World Forum for Harmonization of Vehicle Regulations

Working Party on Lighting and Light Signalling (GRE)

Proposal for Supplement 15 to the 00 series of amendments to Regulation No. 91 (Side-marker lamps)

Submitted by the expert from Germany*

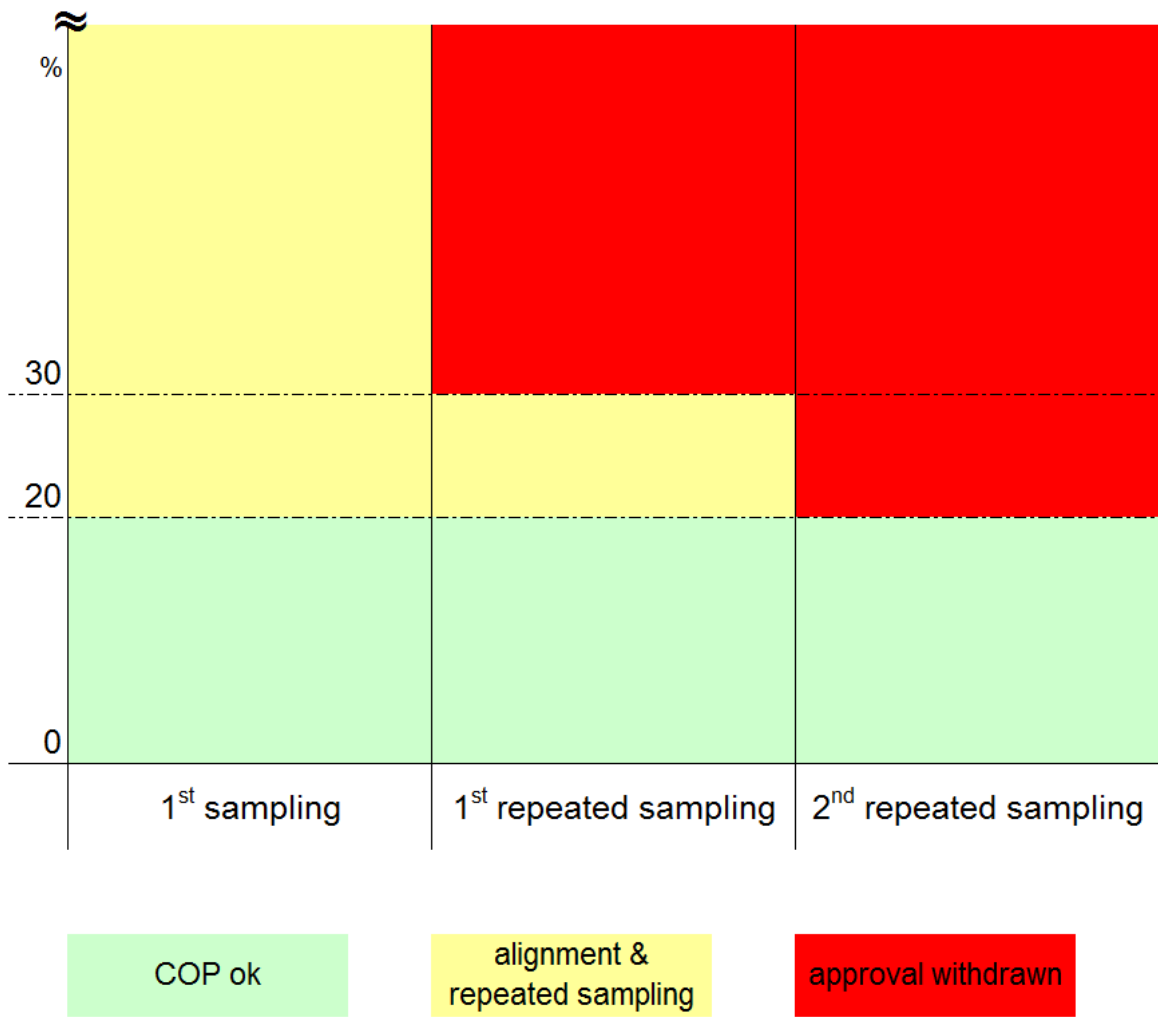
6. CoP is now described in a clear structured stepwise process (with limited steps), which gives the manufacturer the chance in the first step - in the case of deviations of more than 20 per cent - to align his production process. Also, the CoP process can be completed earlier when the first two samples are in the full specifications.

7. The proposal details the "third step" which defines the condition where the approval shall be withdrawn, when after the second repetition of this process the manufacturer was not in the position to "align" his production process in the correct way.

8. The attached drawing shall demonstrate this stepwise process.
